Re: 'North Connacht Project' consisting of approximately 59 kilometres of underground cable between the existing Moy substation near Ballina, Co. Mayo and the existing Tonroe substation near Ballaghaderreen, Co. Roscommon

Ref: ABP-313724-32

EirGrid plc. notes the detail of the correspondence, in accordance with Section 182A(5)(a) of the Planning and Development Act 2000, as amended and the request for further information in relation to the effects on the environment of the proposed development.

Figure 2: 110 kV Cable - Typical Trench Cross Section for Ducts in Flat Formation. (Source: Mott MacDonald 229100591-MMD-01-XX-DR-E-2105)

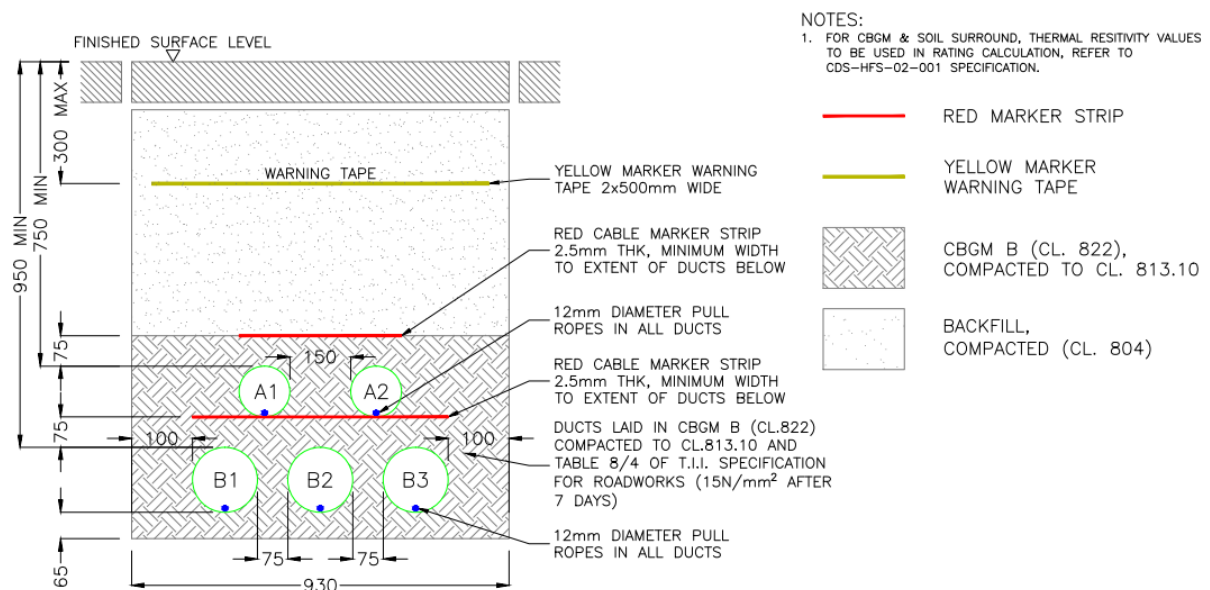
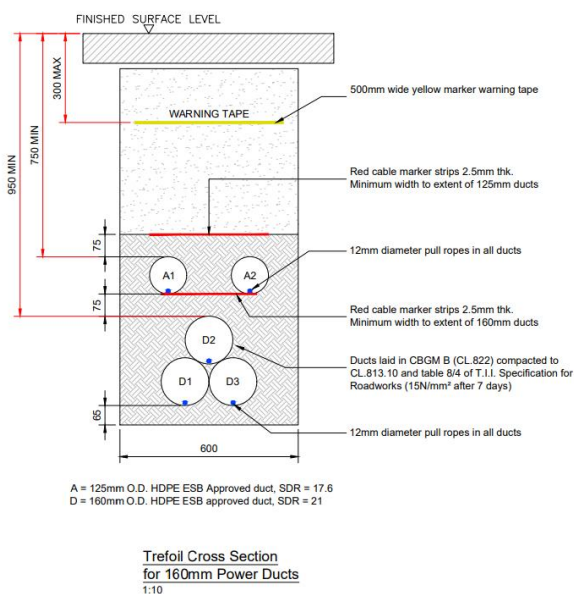
6 Please provide further information as to how it is proposed to install and maintain and reinstate the cable and trench network along the National Road Network, how it is proposed to install and maintain and reinstate the joint bays along the National Road Network to the standard required to ensure the safe operation and capacity on the network, particularly along the running lane of the national road network. In this regard further details are required in relation to the reinstatement of the road pavement surfacing, sub-base, capping layers and any geotextile strengthening layers, particularly having regard to the high proportion of HGV traffic using the national road network and the potential implications which any substandard re-instatement could have for the structural integrity of the road network.

The typical cross sections of a 110 kV cable trench are shown below in Figure 2 and 3 (Enclosure 5). These include three 160mm power ducts, and two 125mm communications ducts. The trench width is either 930mm maximum or 600 mm and the minimum depth to the top of the power ducts is 950mm. This would be typical of installation where there are no utility services or other restrictions. The reinstatement, road resurfacing, sub-base, capping layers and any geotextile strengthening layers will be as per TII specification "Requirements for the Reinstatement of Openings in National Roads CC-PAV-04007" and Guidelines for Managing Openings in Public Roads.

The trench will be installed as straight as possible with long gradual curves wherever required and practicable. The installation will be as close to the road edge as possible, with a preference for installation in the hard shoulder in the case of national roads where possible. This will have the advantage of reducing traffic impact during installation due works being carried out in the hard shoulder instead of the road carriageway.

Figure 7: 110 kV Cable – Reduced Depth for Crossing Over Service (Source: EirGrid XDC-CBL-STND-H-002 Sheet 002)

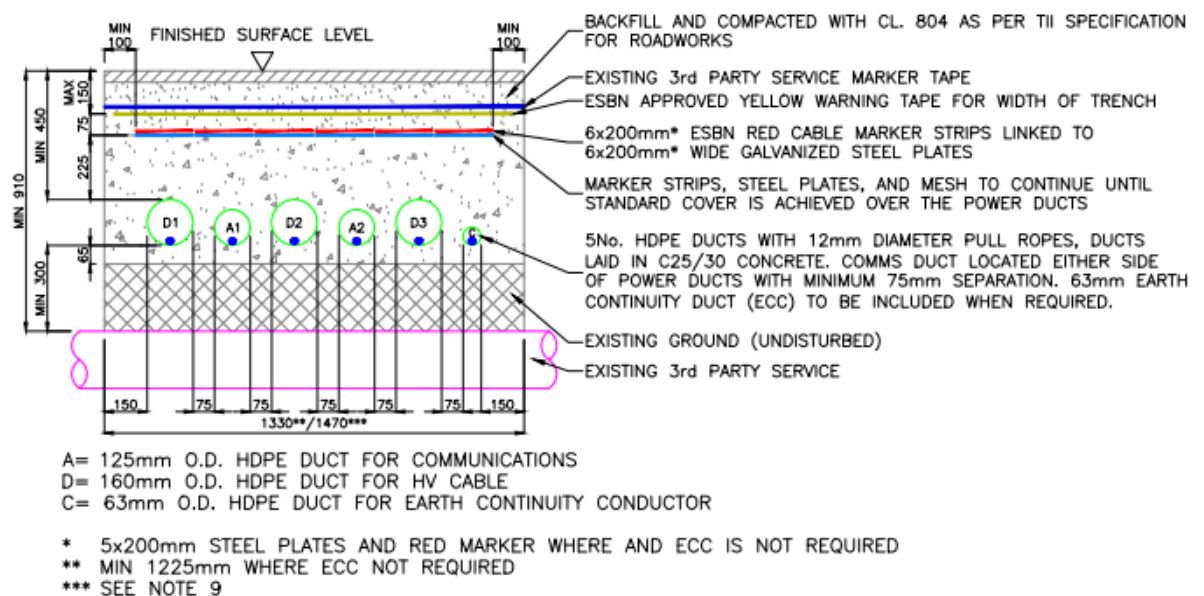
9 Further details are required as to how the cables will be placed within the road specifically in the context of other subsurface elements such as road drainage, culverts etc and how any potential conflicts between the various utilities/drainage arrangements which may arise would be successfully addressed.

Where existing utilities need to be crossed or other obstacles are encountered (e.g. culverts), the depth to the top of the power ducts could be deeper or alternatively could be reduced to a minimum of 450mm as shown in Figure 7. (Enclosure 9).

In the case of shallow burial, steel plates will be installed above the ducts and the ducts will be encased in C25/30 rapid hardening wet concrete. The duct formation in this case has been flattened out with the communications duct placed between the power ducts. A shallow installation would widen the trench to between 1225mm and 1365mm approximately.
